**RESPONSE TO EPA COMMENTS
BHS CORRECTIVE ACTION AND SELF-IMPLEMENTATING PLAN – AMENDMENT 1**

RE: Burlington High School Abatement, Demolition, and Soil Remediation Project
Burlington, VT

FROM: Fuss & O'Neill, Inc.
205 Billings Farm Road
Suite 6B
White River Junction, VT 05001

DATE: December 16th, 2022

Attachment 1 - Figure CAP-2

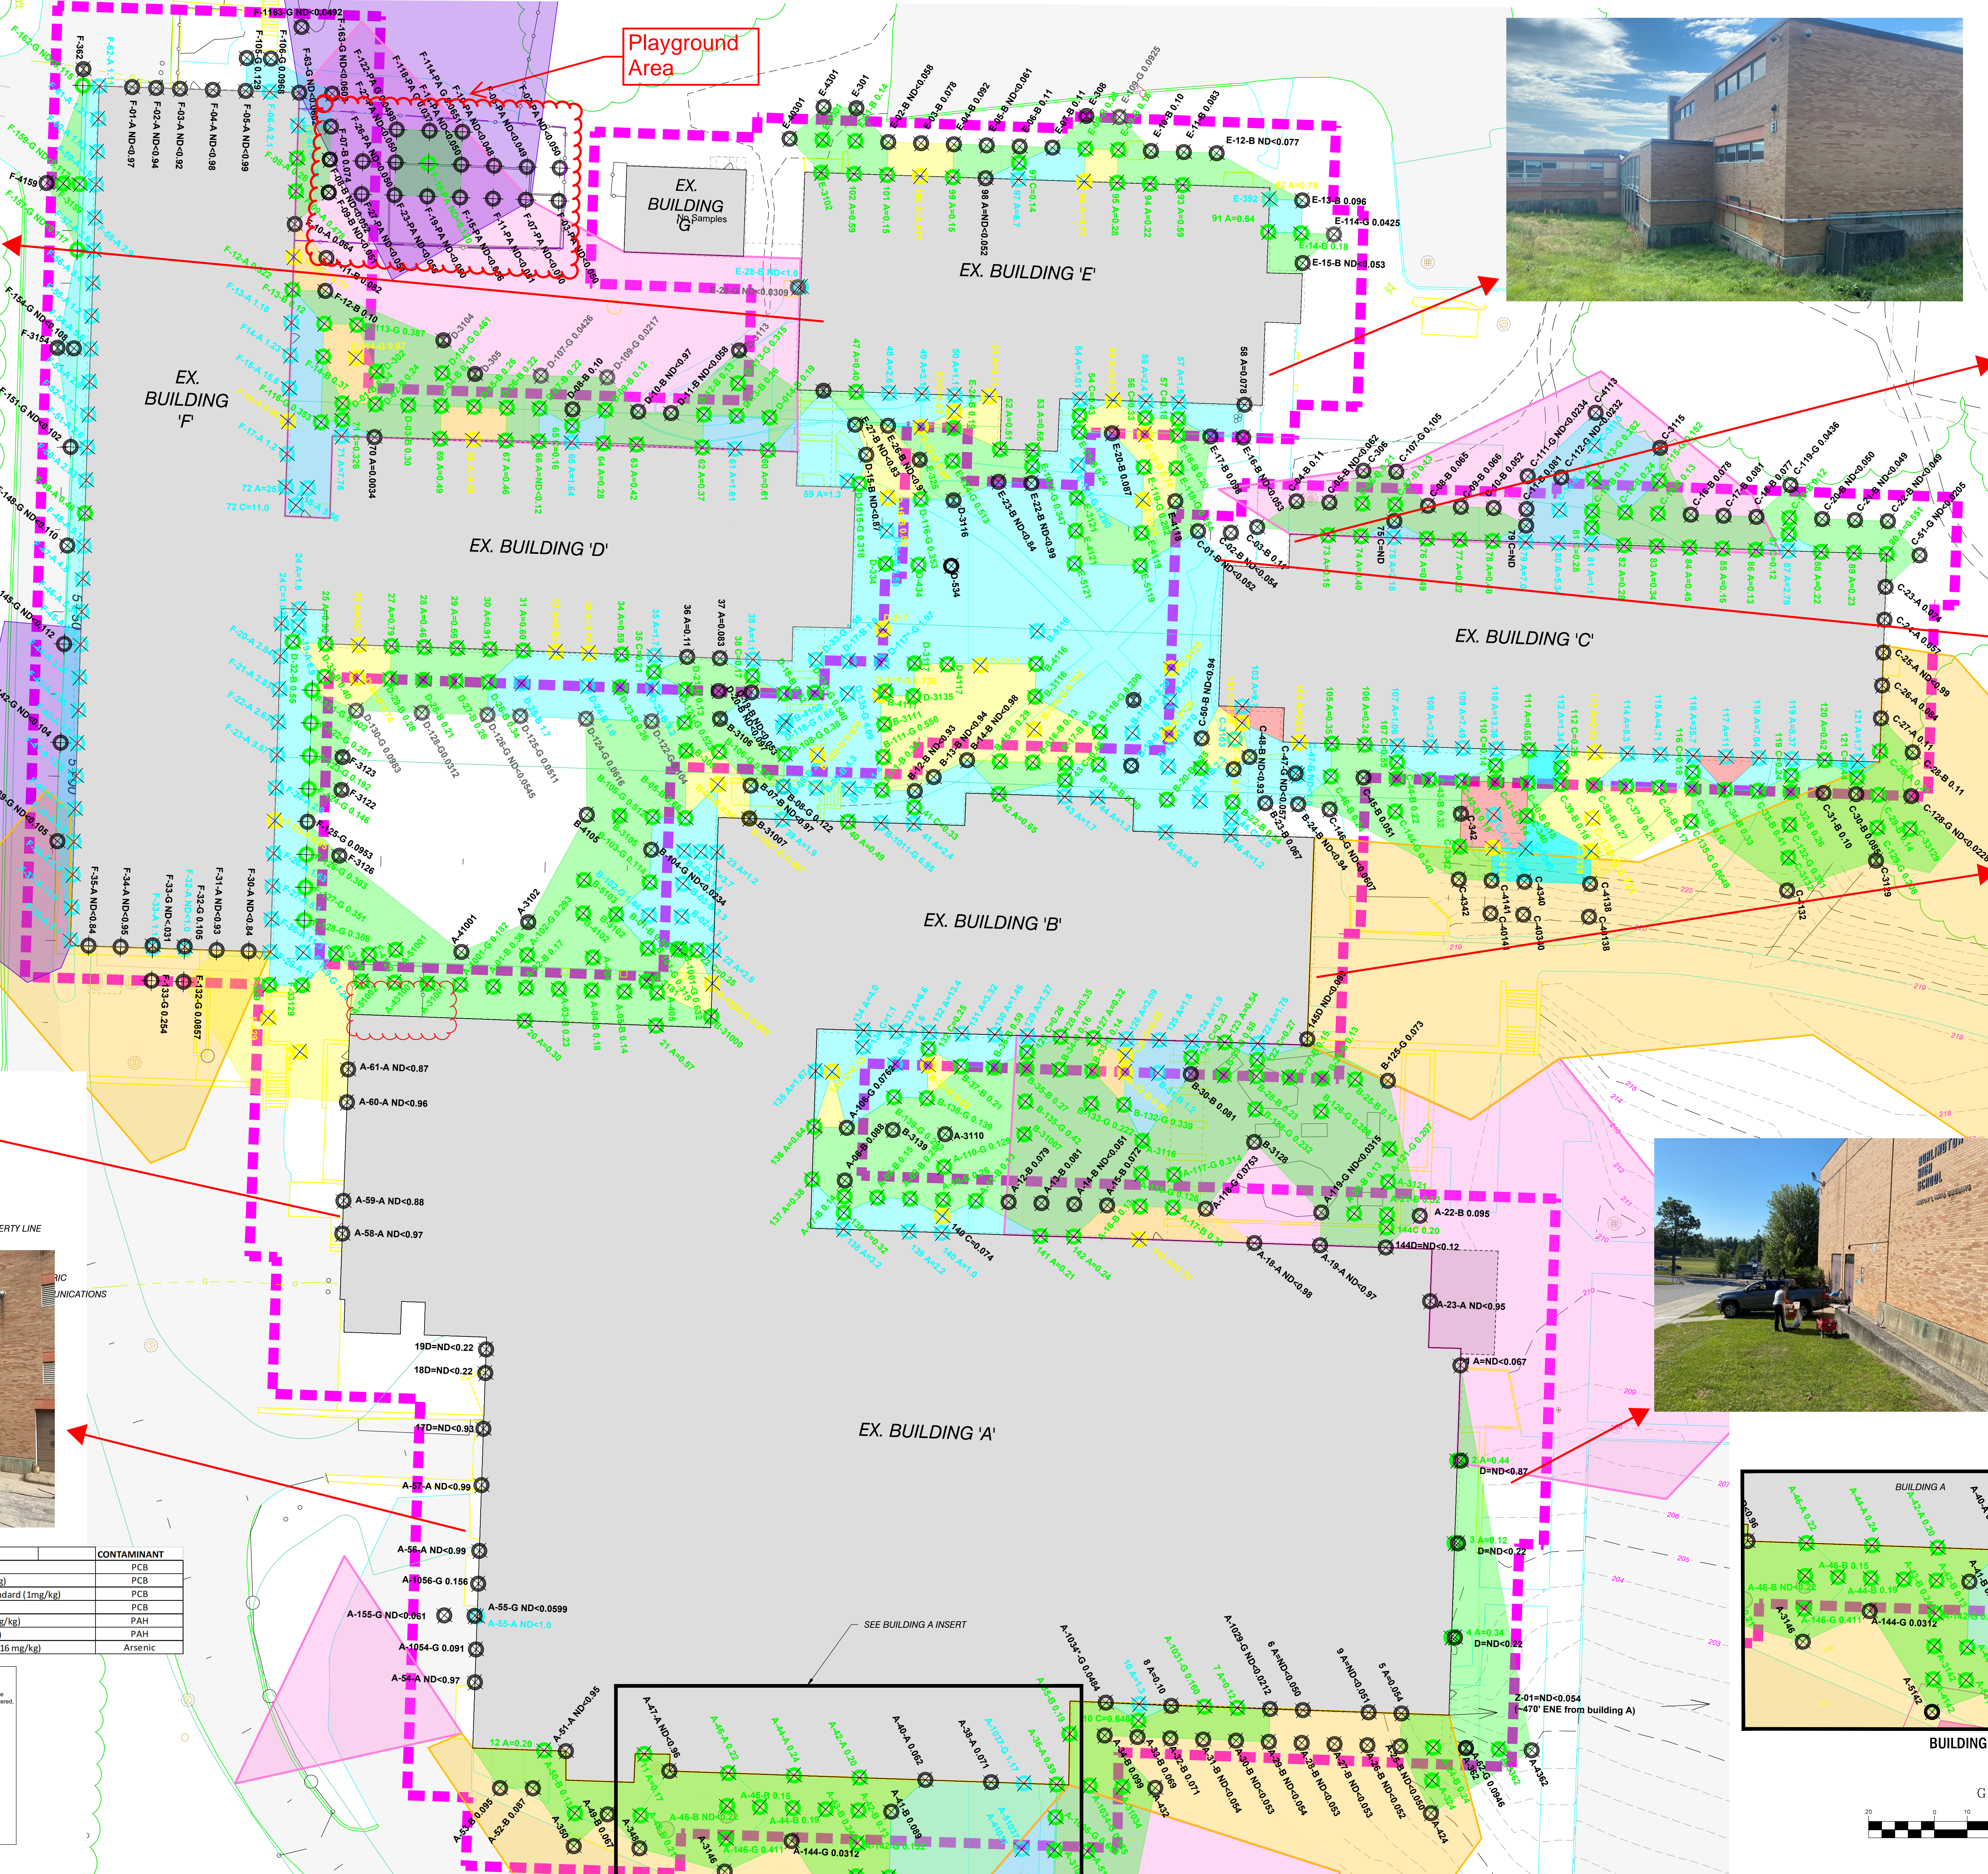
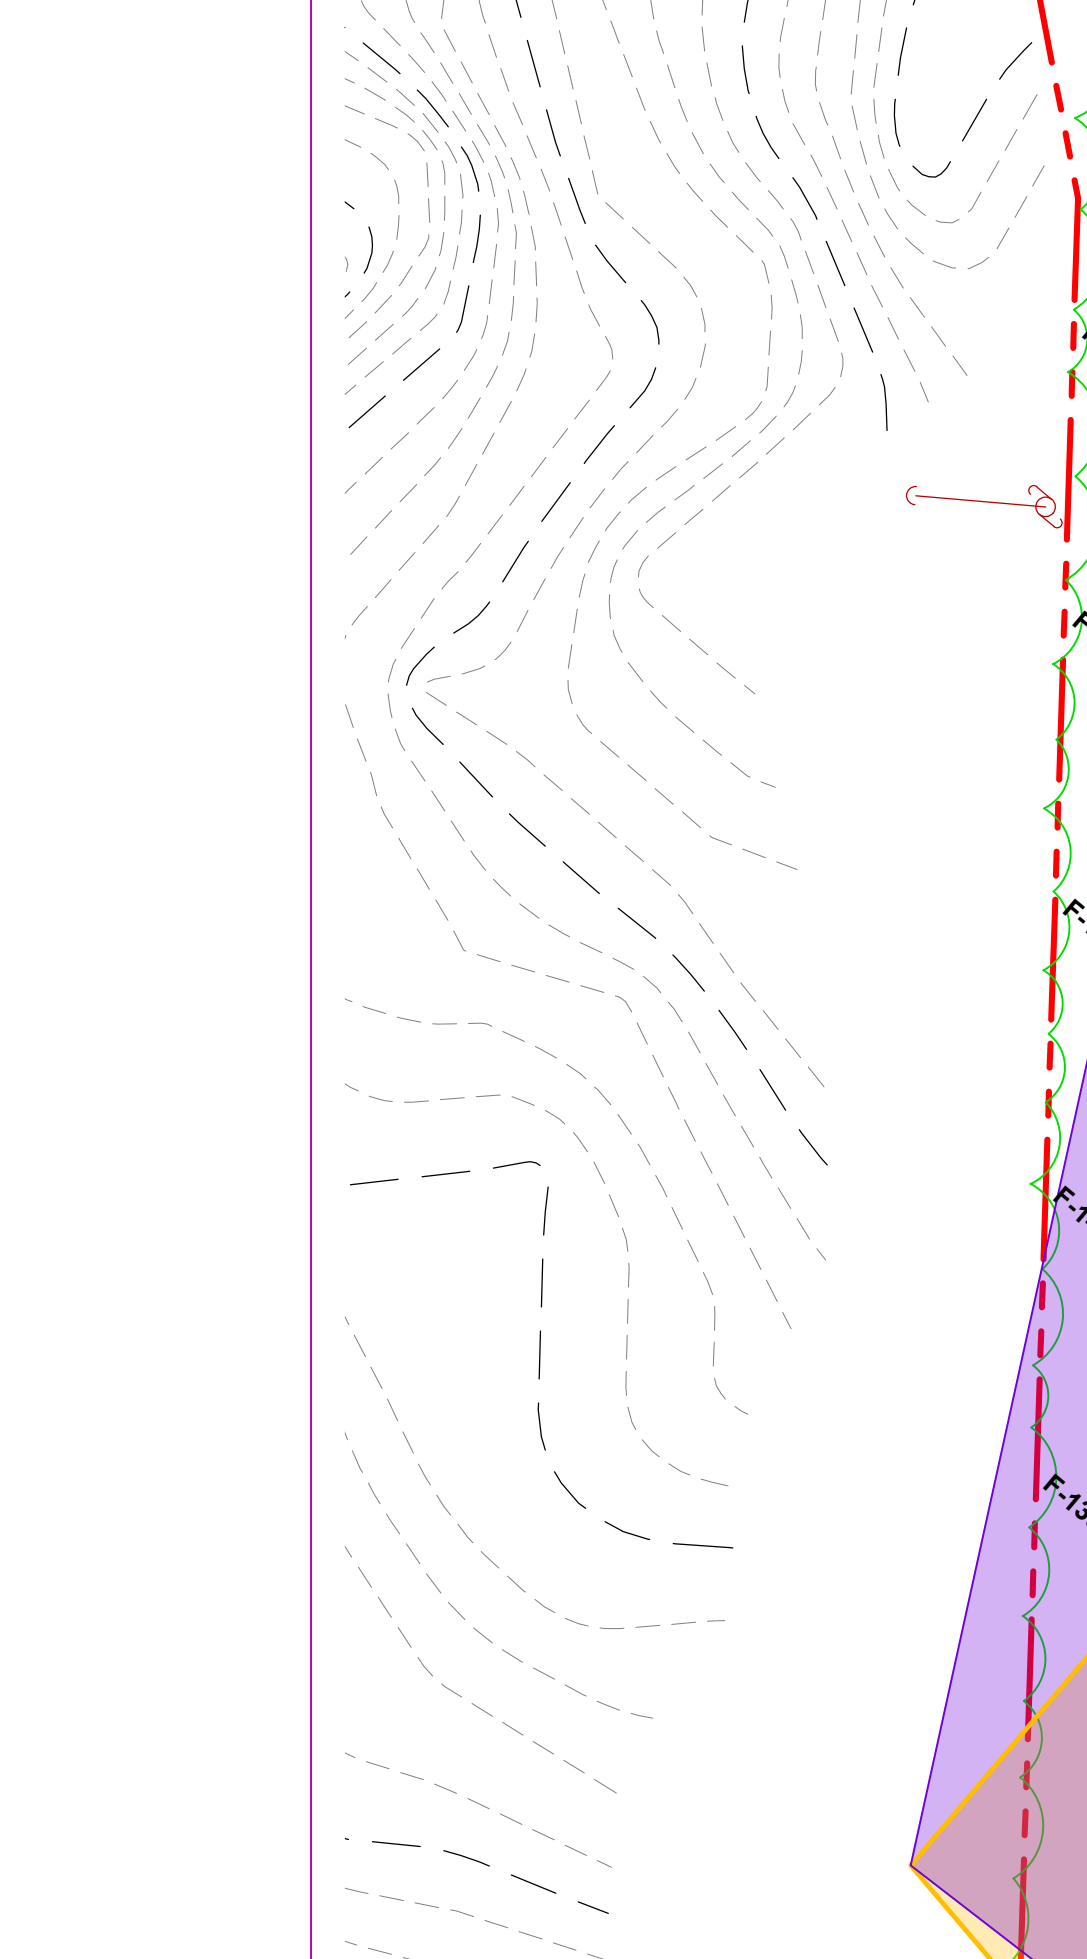
2. **Question:** Section 4.7 – The discussion regarding AOC#9 identified PCB contaminated soils around the buildings and in the Building F Play Area. I do not see the Play Area identified on the figures. Can you please clarify where this is located and concentrations found? I assume this area falls into what is proposed for excavation and disposal?

Answer: The play area is called out on the attached Figure CAP-2 (*Attachment 1*). One soil sample identified as F-18-PA was determined to exceed the Vermont Residential Soil Standard (0.114 mg/kg) due to a reporting limit of 0.12 mg/kg. No other soil samples from the play area exceeded applicable VTDEC or EPA soil standards.
